RE: Delivery Order #108N with Modifications, DACW72-99-D-0005; Second Comprehensive External Independent Review of Delaware River Main Stem and Cannel Deepening Project, Pennsylvania, New Jersey and Delaware: Reanalysis of Project Benefits and Costs

DELAWARE RIVER MAIN CHANNEL DEEPENING PROJECT AND REANALYSIS OF PROJECT BENEFITS AND COSTS: AN EXTERNAL INDEPENDENT REVIEW

Second Review Report: September 2002 Reanalysis Report

Final Review Document

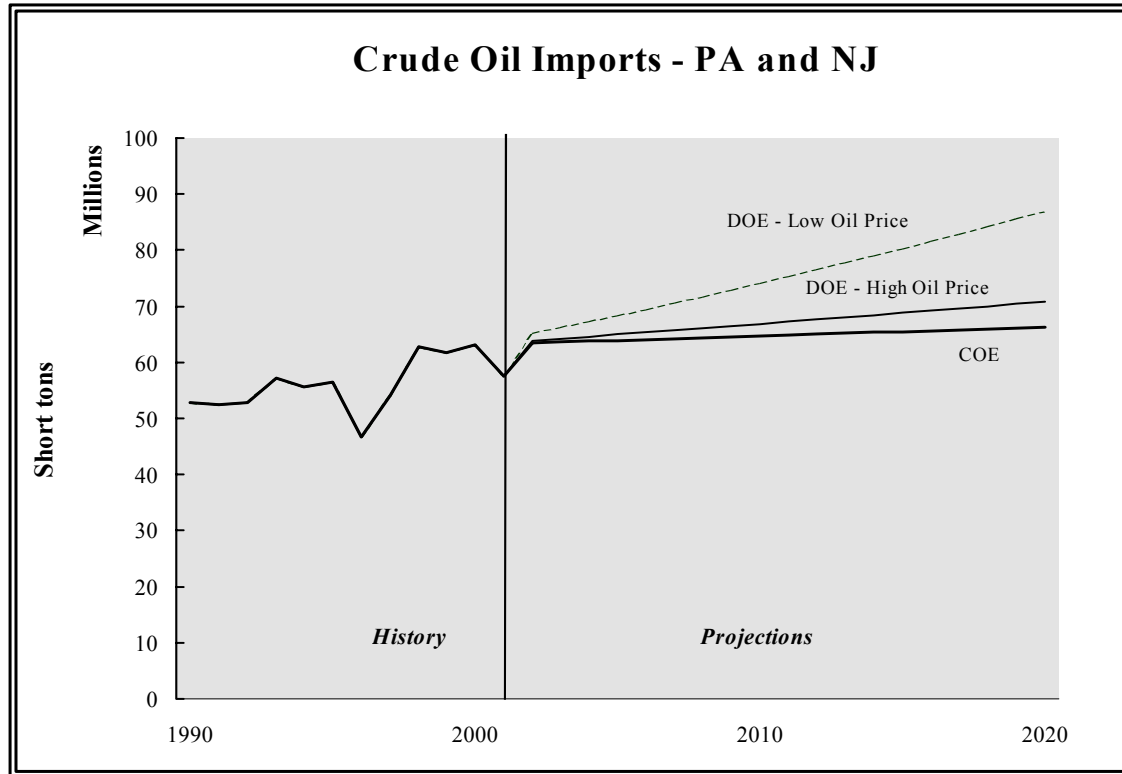
- Container data cited in the text of the response do not seem to match the graph. The graph appears to show very gradual growth in 1995-2000 and a more aggressive forecast. Also, some explanation should be given for the emphasis put on growth over the last five years.

Historic PIERS tonnage data from the Delaware River Port Authority (DRPA) for Pennsylvania and New Jersey for 1) crude oil imports (excludes Motiva), 2) containers (excludes Port of Wilmington), and 3) steel slab imports, for the 12-year historic period from 1990-2001 has been assessed in this analysis. DRPA was not able to provide information specific to another benefiting commodity, refined petroleum products for Delaware Terminals, located in the state of Delaware; however, the historic pattern for this commodity should approximate crude oil imports. An additional benefiting commodity, imported slag to Beckett Street Terminal, just commenced moving through the port in 2001, so no long-term historic set of data is available. Also, the crude oil data provided by DRPA for this entire period has consistently applied the old PIERS conversion factor. Please note that the year 2000 crude oil import data used in the Corps benefit analysis as the baseline has properly adjusted the PIERS conversion factor. Graphs of historic tonnage and future projections to year 2020 are displayed in Section B. below.
